# Development Management Sub Committee

**Application for Planning Permission 14/04880/FUL  
At Land 196 Metres South Of 49, Burdiehouse Road,  
Edinburgh  
Proposed residential development of 211 new houses and  
flats with associated infrastructure (as amended).**

## **Application for Planning Permission 14/04880/FUL At Land 196 Metres South Of 49, Burdiehouse Road, Edinburgh Proposed residential development of 211 new houses and flats with associated infrastructure (as amended).**

*4. Flood Risk*

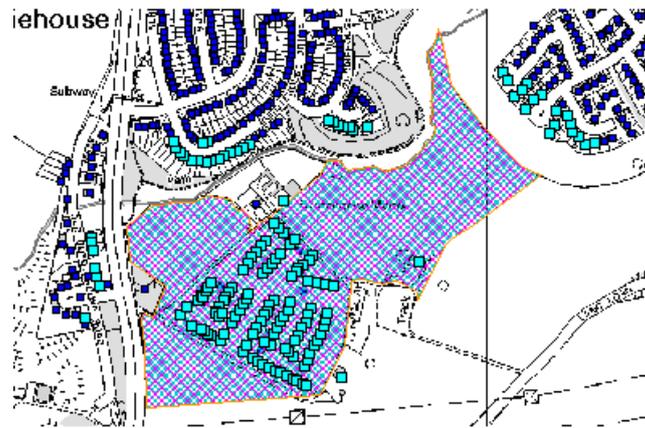
*4.1 The SEPA Flood Maps have been produced following a consistent, nationally-applied methodology for catchment areas equal to or greater than 3km<sup>2</sup> using a Digital Terrain Model (DTM) to define river corridors and low-lying coastal land. The maps are indicative and designed to be used as a strategic tool to assess, flood risk at the community level and to support planning policy and flood risk management in Scotland. For further information please visit <http://www.sepa.org.uk/environment/water/flooding/flood-maps/>*
